SUMMARY OF ANALYSES OF D.C. COOK CONTAINMENT RESPONSE TO HYDROGEN TRANSIENTS

REPORT NO. 36A05

ITEM 1 OF ATTACHMENT 3 TO AEP:NRC:00500

SMA has reviewed the report entitled "D. C. Cook Nuclear Power Plant American Electric Power Estimate of Ultimate Pressure Capacity of Containment Structure" dated 26 September 1980, prepared by Harstead Engineering Associates, Inc. which was transmitted to AEP from the NRC by letter from S. A. Varga dtd. 6 November 1980.

SLIDE 4

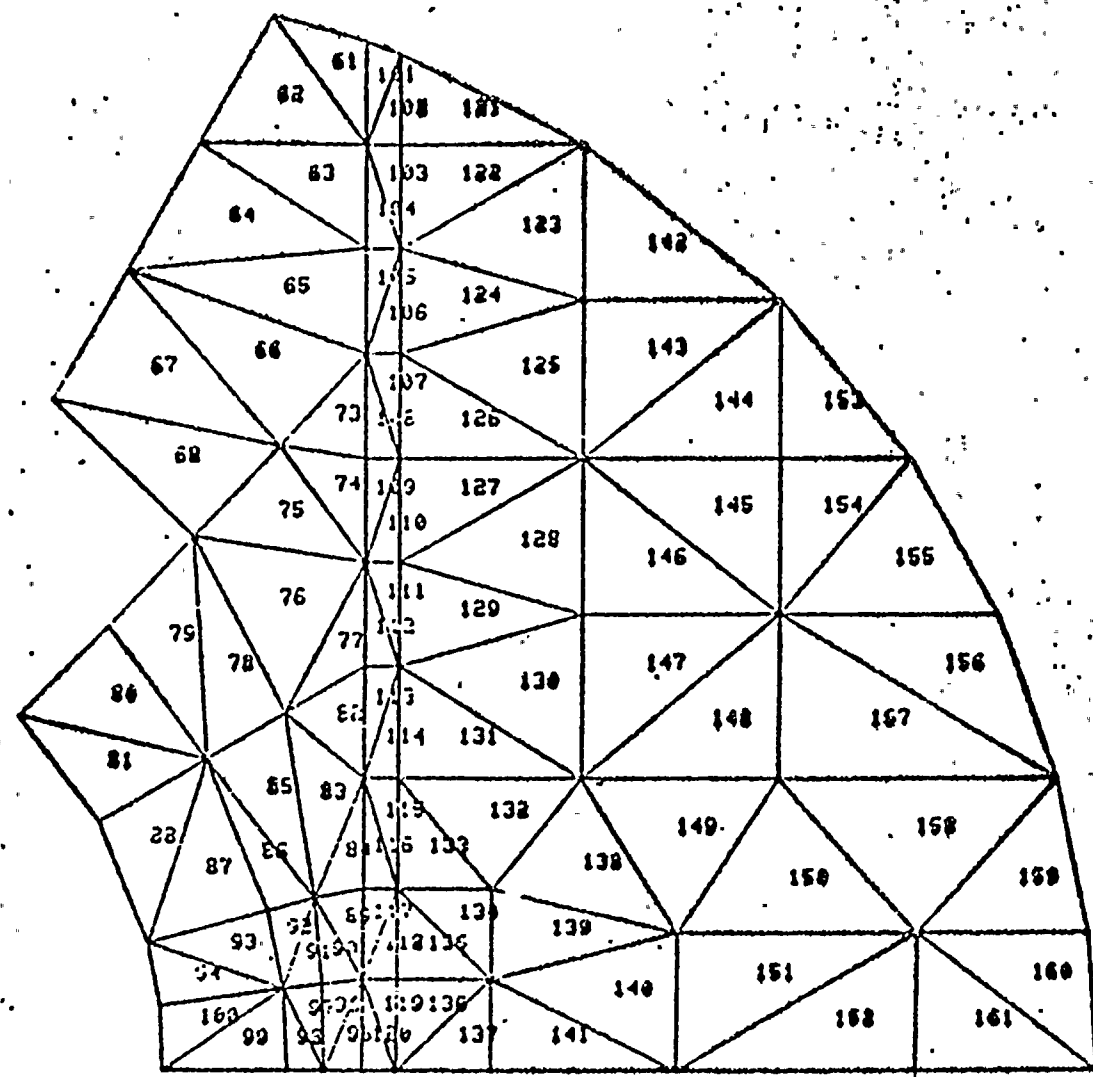
The bulk of the rest of the meeting was an oral presentation by Dr. Stevenson and a discussion of Harstead's report highlighting the areas of disagreement which are shown on Slide 3 which is summarized in Item 2 of this communication. In addition Dr. Stevenson briefly summarized the results of the hatch finite element analysis performed to date indicating the maximum moment in the hatch plate is occurring adjacent to the personnel hatch and not in the equipment hatch plate splice. A finite element model was shown in Slide 4.
